Table of Contents

**APPLICATION FOR EXTENDING GAA NZG 458 at PAEROA RANGE - ROTORUA
AIRSPACE**
From AUCKLAND HANG GLIDING & PARAGLIDING CLUB and
WAIKATO HANG GLIDING & PARAGLIDING CLUB

2016 WAIKATO and BAY of PLENTY AIRSPACE REVIEW

Airways New Zealand submission to the Civil Aviation Authority's 2016 Waikato and Bay of Plenty Airspace Review

Airways DRAFT Proposal dated 30 July 2015

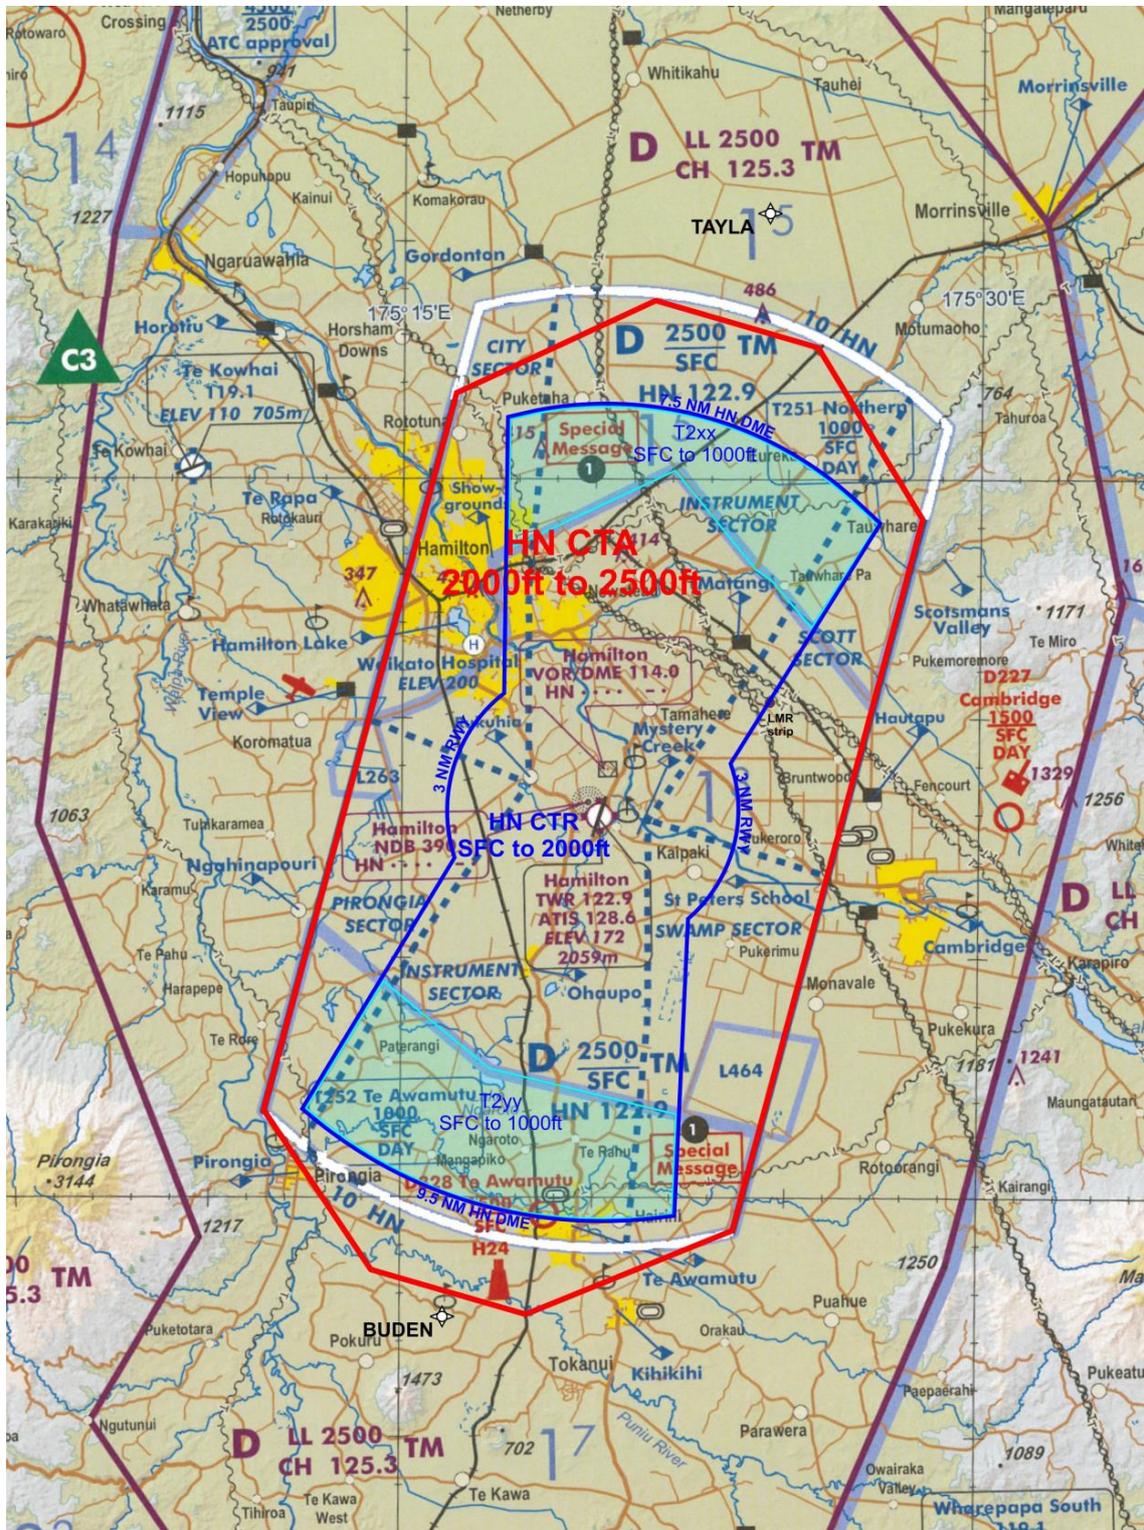
1. The design reduces the size and upper level of the HN CTR as much as practical to contain the instrument approaches and departures and provide suitable containment of circuit operations at HN.

The design would require the existing VOR/DME and NDB/DME approaches to be amended so that they turned inbound at 3,000ft or above.

2. The upper level of the DRAFT CTR is 2,000ft AMSL, lower than the existing 2,500ft.
3. The existing HN CTA LL 2500ft (NZA245) remains unchanged.
4. The lowered CTR upper level requires the addition of a new HN CTA airspace extending from 2,000ft to 2,500ft to reach the lower level of NZA245. In general, the lateral dimensions of this new CTA are the same as the existing HN CTR but note the small extension to the south.
5. Airspace containment criteria applied

12. Unfortunately, the Lee Martin Road Airfield (LMR strip) does not lie outside the DRAFT CTR.

Based on the photo of the LMR strip on the Aerosport website, Airways believe that the DRAFT CTR boundary would pass over the centre of the strip (orientated 10-28) – i.e. the western half of the strip would be inside the CTR, whereas the eastern half would be outside.

VOR/DME RWY 18L cat A and B – NOT contained by the proposed new airspace.

This approach needs to be amended/extended so that it is not below 3,000ft until inbound and inside 9.5 DME and not below 2,500ft inside 7.5 DME.

Some possible solutions that could be put to CAA for their consideration are;

1. A reduction in the airspace containment criteria in that area which would allow a small indentation in the CTR boundary around the LMR strip; or
2. The addition of a small transit lane (about 0.5 NM diameter?) around the strip with an upper level 700ft AMSL.

G254/255

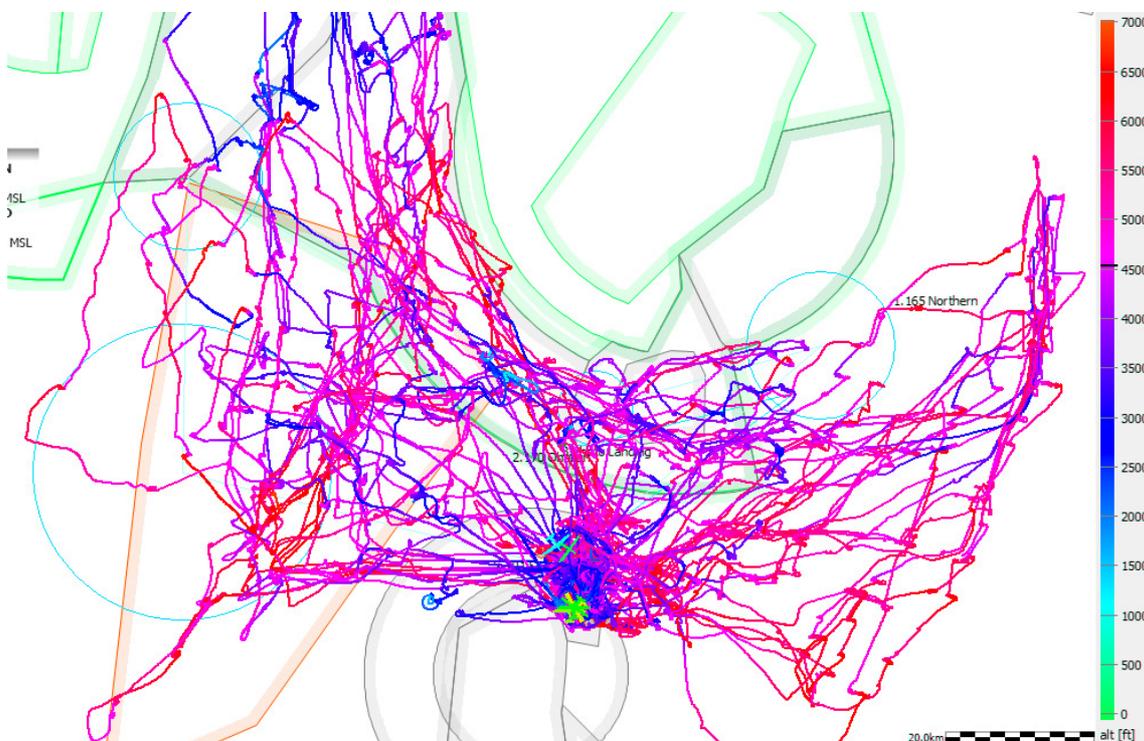
The current area G254 is fundamentally important for basic glider operations in the Matamata area. This is a busy gliding area with club operations and contests bases out of the Matamata aerodrome. Having this area “on our request” also allows certainty for glider ops. Historical data would show that it is typically activated in the afternoon and closed late afternoon/evening. In other words it is used for perhaps 25% of any day. Further, gliding above 4500ft mostly happens when very good VFR conditions exist, which over the summer months is probably on 40% of the available days. And lastly, glider operations are often, but not exclusively, on weekends, public holidays and Wednesdays.

So the use of G254 (and 255) is likely to be a maximum of only 5-6% of any given year.

A solution to the problems surrounding G254/255 and the area between G225 and R299 maybe to lift the whole Waikato CTA/D to 5500ft. This would probably reduce the requests to open G254 and G255 almost to zero, and almost eliminate individual requests for access to controlled airspace in the vicinity and therefore reduce workloads for controllers and pilots. Some thought would need to be given to the area around Wharepapa Sth (with an extension as far west as possible) and what extensions could be made into the western side of the RO CTA/D. Again, good utilisation of the planned PBN flight lanes should provide a guide.

Fig a. What is possible, but leaves no room for errors

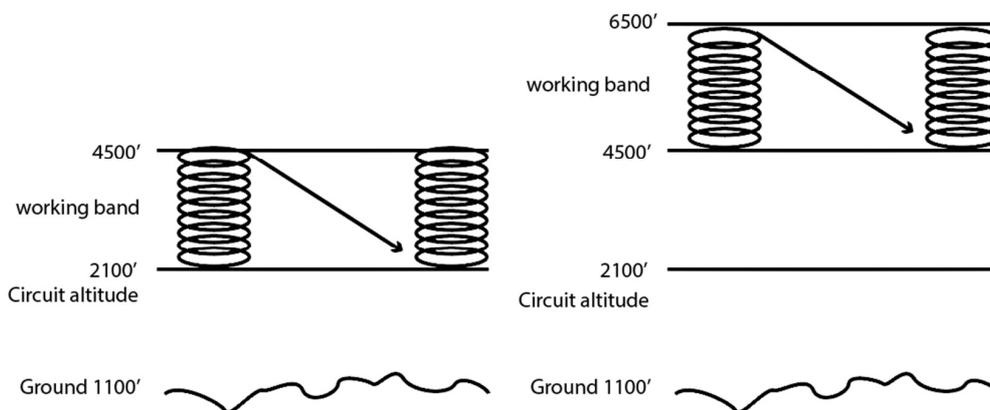
While it is possible to fly around this higher country under 4500', it leaves little room for error, unexpected sink, or problems with landing areas. **In general glider pilots want to remain above 4500' feet at all times**, especially when flying over terrain that is elevated.

In addition 4500 feet is right on the boundary that a pilot is often going above and below. Thus dropping in and out constantly of controlled airspace can be an issue.

Figure I. Suggested trimming of the Hamilton airspace corner.

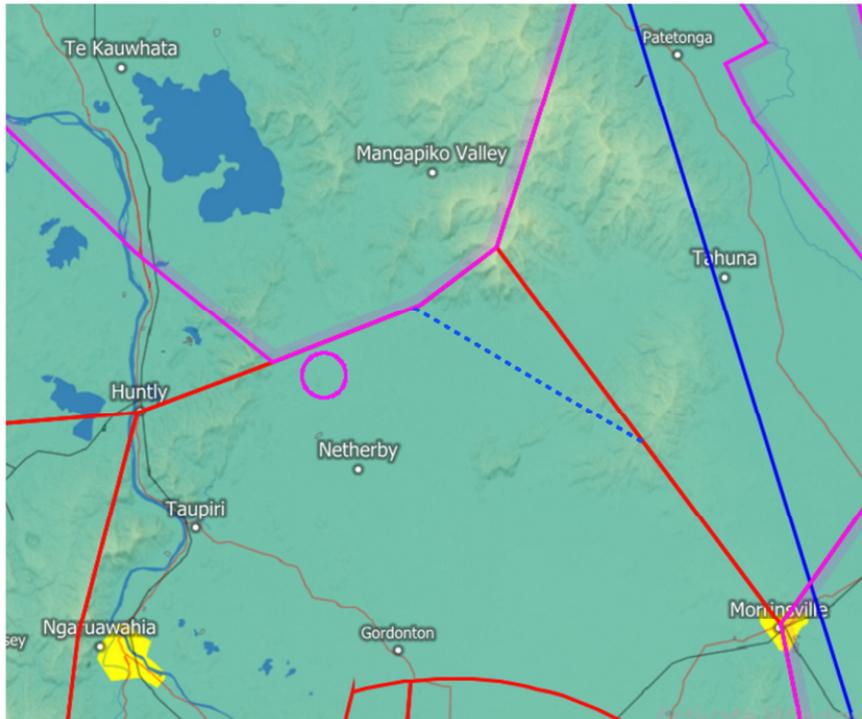
Trim the northern corner of Hamilton airspace. This airspace cuts right into the transit path for gliders heading towards Huntly and Te Kawhata area. The hill peak that the corner of the airspace hits is right where gliders want to climb. This is often used in transit from Drury to Matamata by gliders. The dotted line in Figure I is a suggested new boundary for NZA245

Figure K. Suggested new G255 shape that allows transit south.

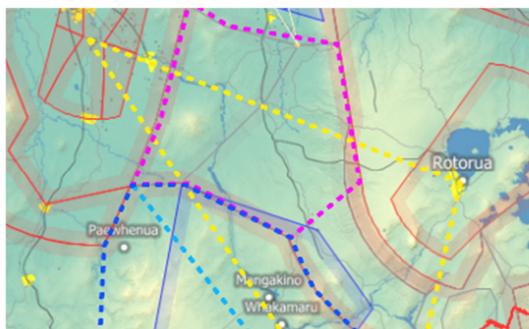
- 1) The area is not available most of time, because controllers generally don't like to open both G254 and G255 at the same time.
- 2) The shape doesn't support transiting south easily. It narrows at the bottom, so calling to cut through the corner of the Tokoroa airspace is usually necessary, yet only for a few minutes, thus adding to workload of controllers with little benefit.
- 3) The same applies returning home from the Pureroa ranges. 'Final glide' home cuts through this corner as well as seen in Figure J below.

The suggestion is to increase the size of G255 to include enough space to transit south, and make use of the Mamukus towards the edge of the Rotorua airspace. The dashed pink area in Figure K indicates the potential new shape. Height would remain the same, 4500-6500 feet.

This would also need to be available to open up at the same time as G254 with a certain reliability. Switching to opening by notification would solve this issue.

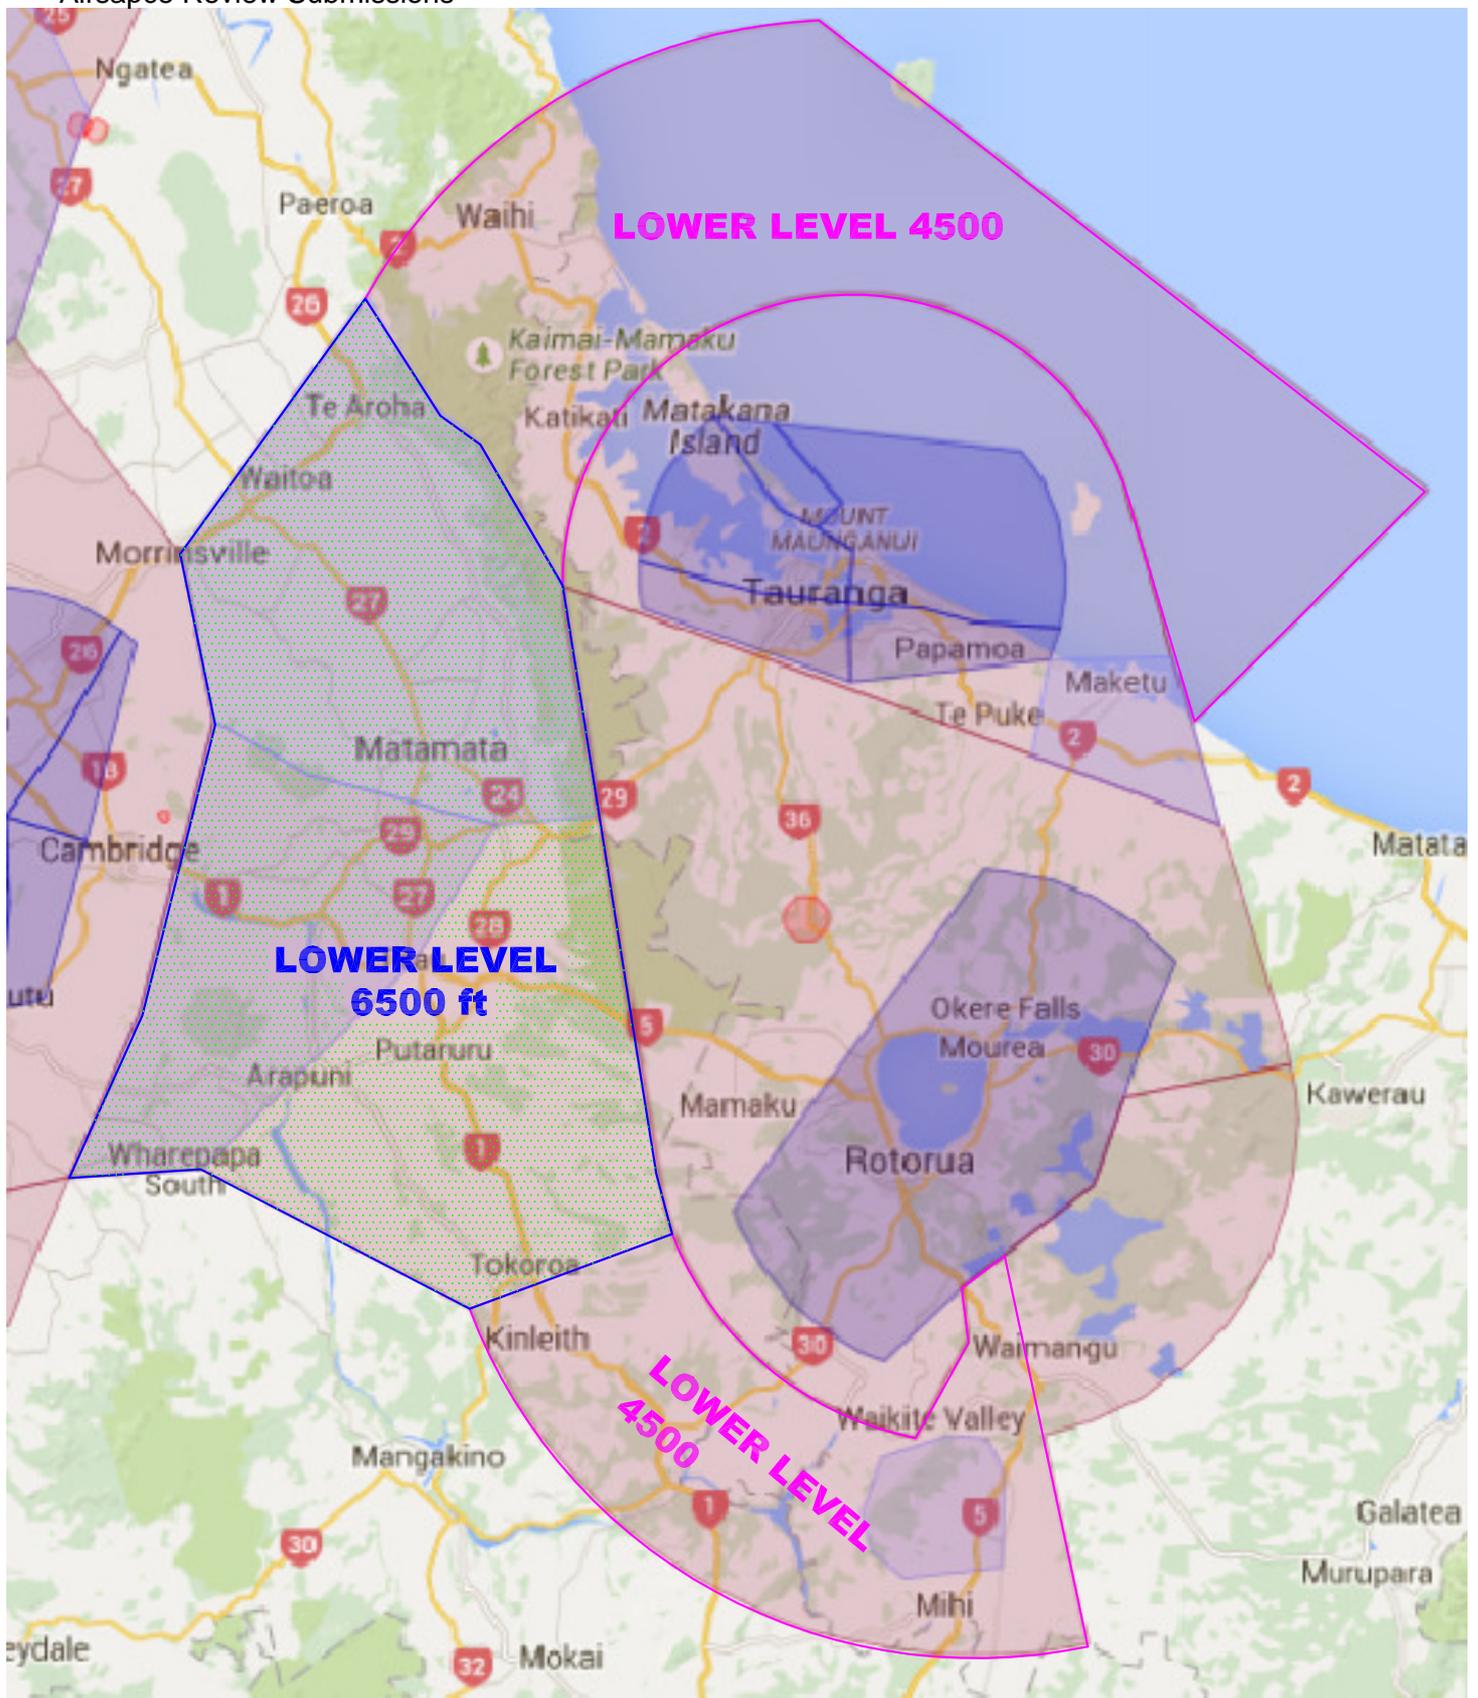
Jeff Ripley of Auckland Hang gliding and Paragliding Club has initially consulted with Airways Bay Sector Manager Brian Walls, to explore the possibility of extending the GAA out to the 25 RO arc to an altitude up to 6500 ft. Brian has looked at this in some detail and notes the following (extract from submission email);

Please note Brian's comment that "Extending Airspace to 25 DME would have minimal impact " and after further consideration it is understood that a height limit of 5500 ft AMSL would solve Airways concerns.

Therefore, the NZHGPA requests that the existing GAA G458 Paeroa Range boundaries be extended as per the enclosed submission map out to RO 25 arc to the South, with an upper limit of 5500 ft AMSL.
